Zoning Staff Report

Date: March 11, 2025 Case Number: ZC-25-001 Council District: 2

Zoning Map Amendment

Site Location: 4501 Angle Avenue & 2851 NW Loop 820

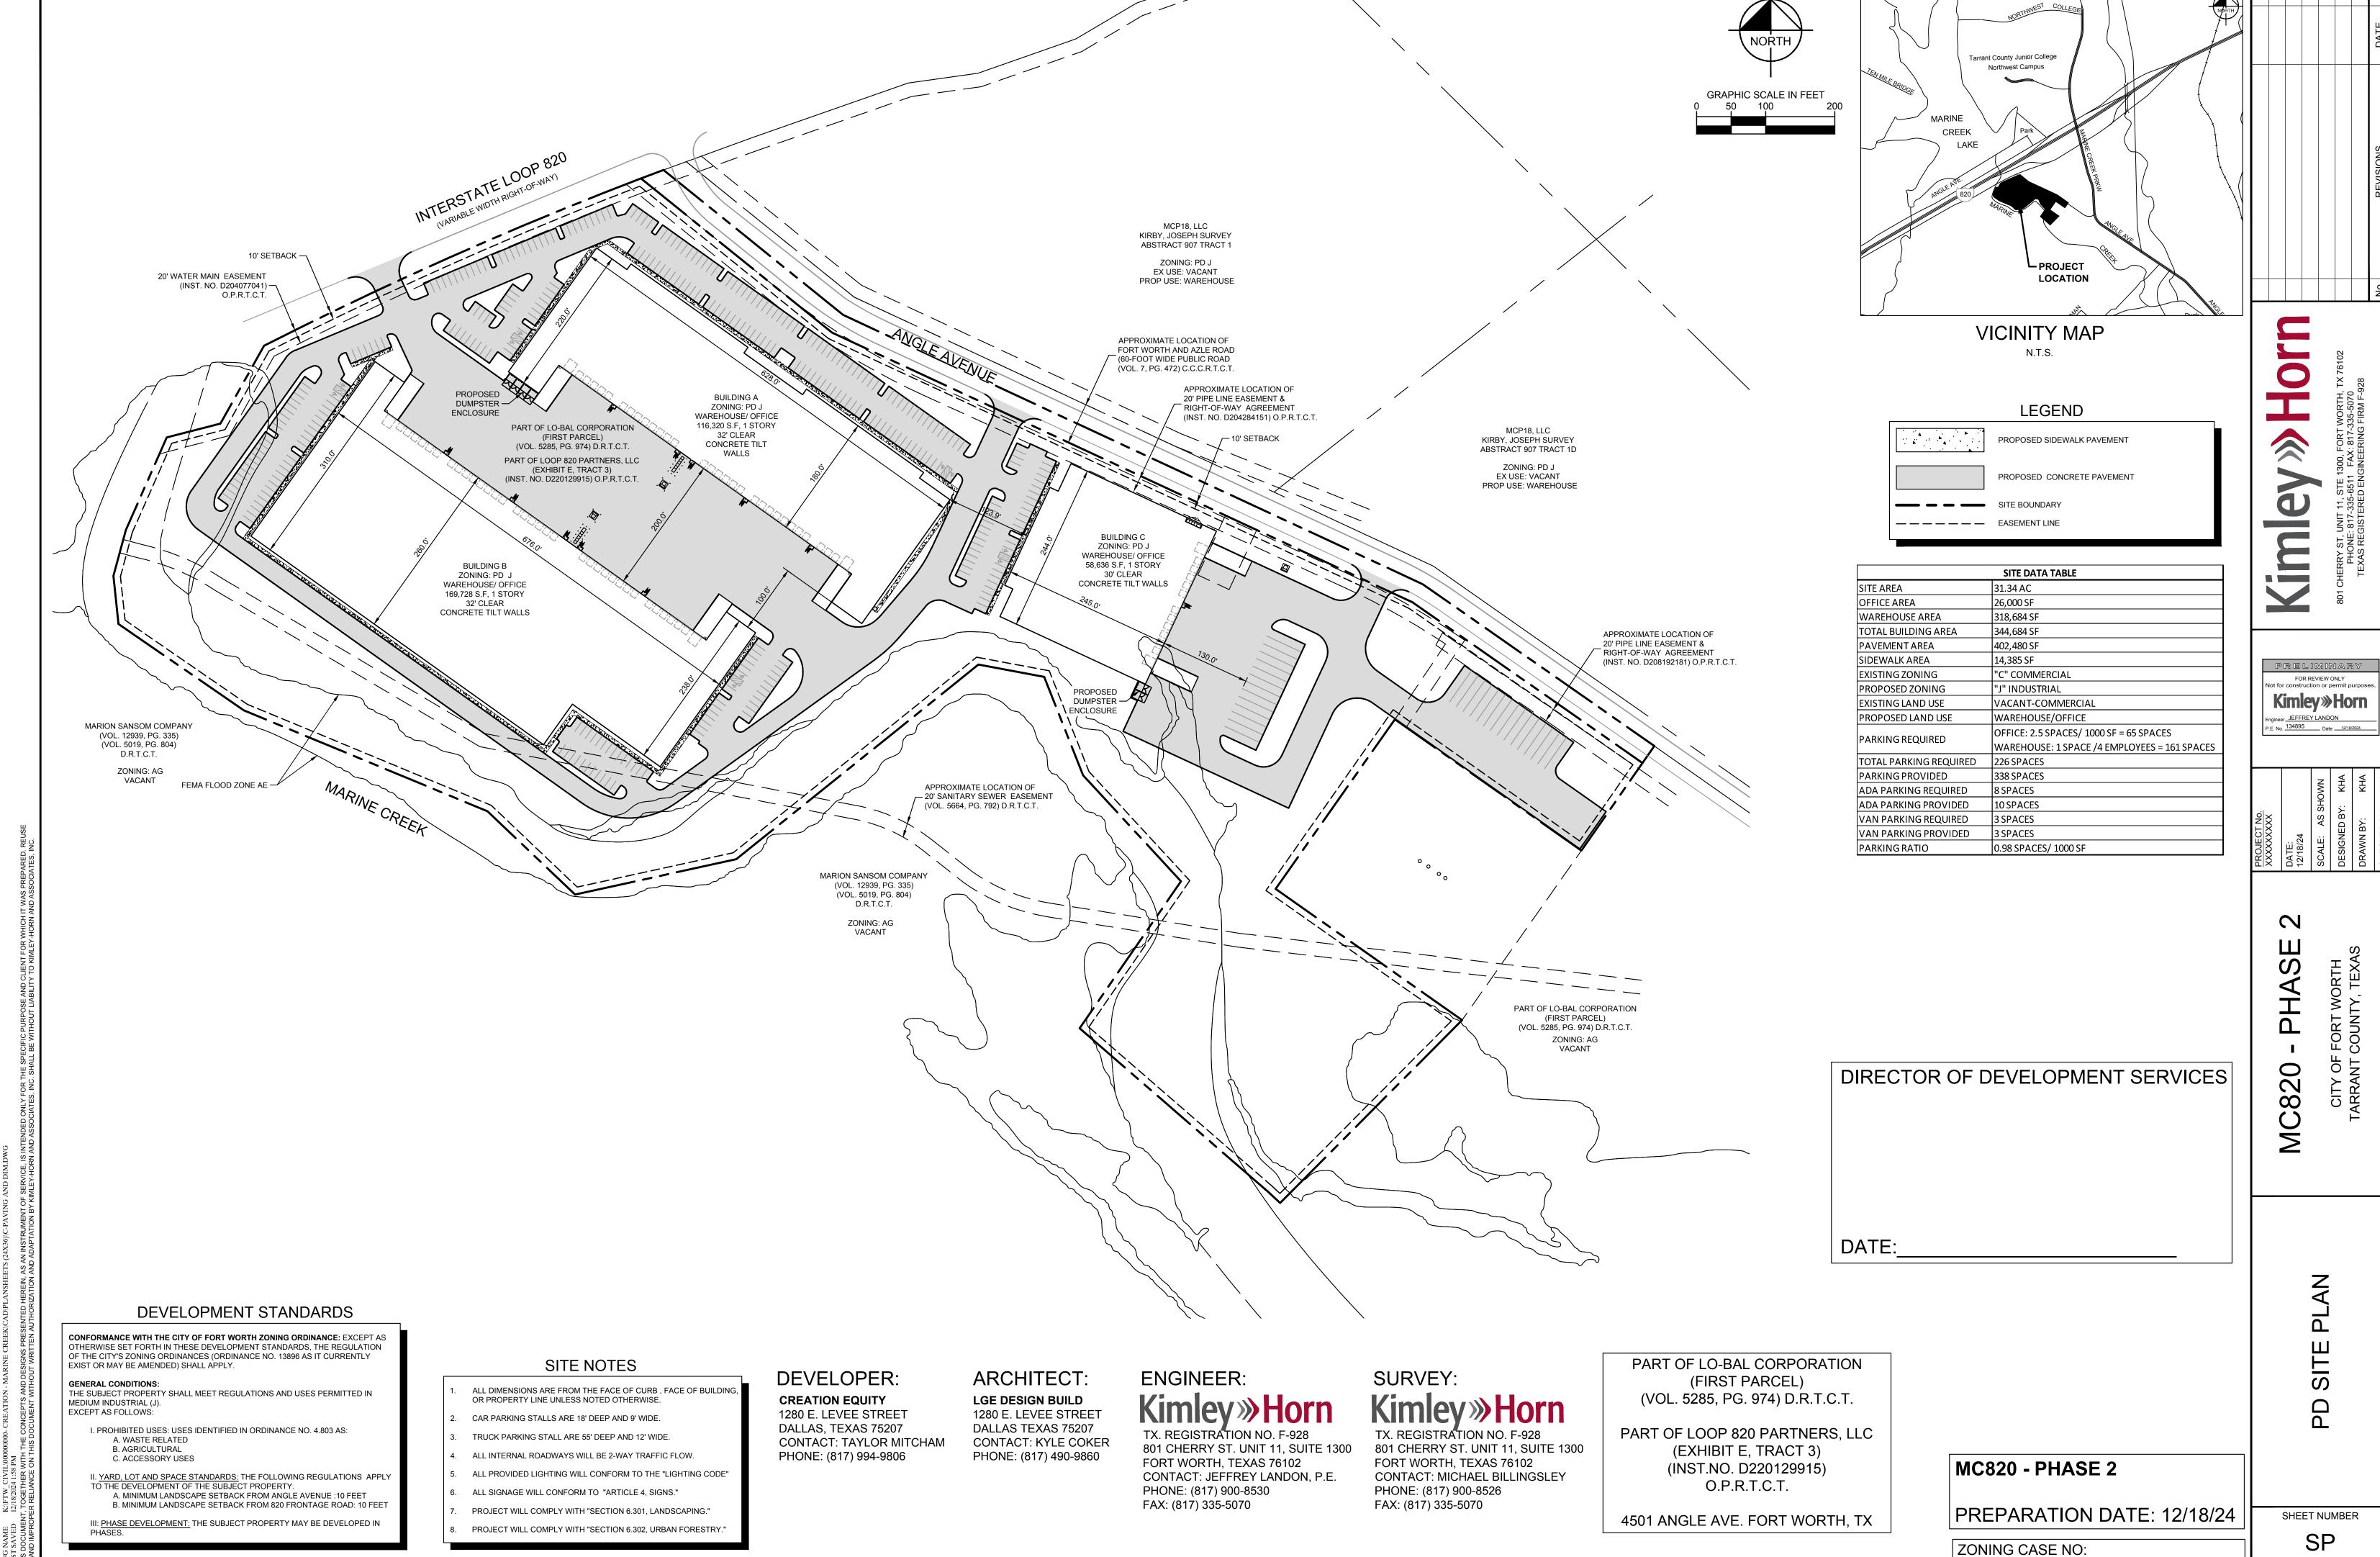
The site plan as submitted is not in general compliance with the Zoning Ordinance regulations.

- 1. Add the address of 4501 Angle Avenue and the metes and bounds legal description. The metes and bounds can be on a second sheet, so the font size is legible.

- 2. Update the case number in the lower right corner to ZC-25-001.
- 3. Show all the entrances (both truck and pedestrian) on all the buildings.
- 4. What are the rectangles on one side of the buildings?

- 5. Label the driveway widths.
- 6. What are the items between Buildings A&B near the 200' label?
- 7. Remove the driveway going to the southeastern adjacent lot. Residential lots are not to take access thru non-residential zoning districts.

- 8. Label the number of parking space groups.
- 9. The ADA spaces do not appear to be the closest parking spaces to a door.
- 10. Add a landscaping texture to the Legend and show the landscaping areas on the site plan.

- 11. Note or label whether the buildings will have ground mounted equipment (AC units, etc.).
- 12. Label the height and materials of the dumpster enclosures.

- 13. Correct the existing zoning to the southeast and southwest.
- 14. Label all setbacks based on the adjacent residential zoning.
- 15. The Angle Avenue street frontage is required have a minimum 20-foot setback due to the projected multifamily front yard. This 20-foot setback is shown. Why is a 10-foot setback development waiver requested when both street frontages have 20-foot existing easements?

- 16. The landscaped area in front of the buildings does not appear to meet the landscaping requirements of 75% of the site's landscaping to be in front of the buildings.

- 17. Show and label all items applicable to Sec. 6.300K with a 50-foot setback, 20 feet of landscaping, and a screening wall or request a development waiver.

- 18. Note that all buildings' exterior materials will be neutral earth tones.
- 19. Note all pedestrian entrances shall consist of storefront glass, canopies and masonry articulation or similar architectural features.

- 20. Show and label the gas well buffers.
- 21. Other solid lines are shown extending from the FEMA AE flood zone. Please label these lines. It might be helpful to add a fill pattern to differentiate the items.

- 1. Site will require an accepted drainage study prior to platting, grading, infrastructure plan review, and building permit issuance.
- 2. FEMA Floodplain and Floodway is on site. There is potential high water on site beyond the FEMA Floodplain that may exceed 5 ft in depth.
- 3. Storm infrastructure is seen out falling into channel from NW Loop 820 per TxDOT Plan Set 8-14-022.

- 1. Gas well setbacks are applied based on the pad site conditions at the time of building permit application. Non-permitted gas well pad site to the east will not impact this site as shown on the plan. Pad site currently is Non-permitted. Setback would include the well bores, a tank battery and adjacent equipment (separators) and a lift compressor.

- Non-permitted gas well site across Angle Ave is non-permitted with a lift compressor, tank battery and separators. By rough estimate, the map shows that Building C is right at 200' from the well heads. Survey will be needed to identify the exact distance. 200' or more is allowed for the Habitable use. Section 5706.

- 2. One access point per lot is required. TXDOT permit is required for any driveway along Loop 820. If the lots are separated by plat, shared access must be recorded as public access. Section 503.1.1 Buildings and Facilities.

- 1. HOLD The site plan identifies that a portion of the proposed building B will be in the sewer easement. Relocate the building and revise the site plan.
- 2. FYI Water and sewer extensions will be required.
- 3. 36" sewer main will require a 30ft easement based on current design policy.
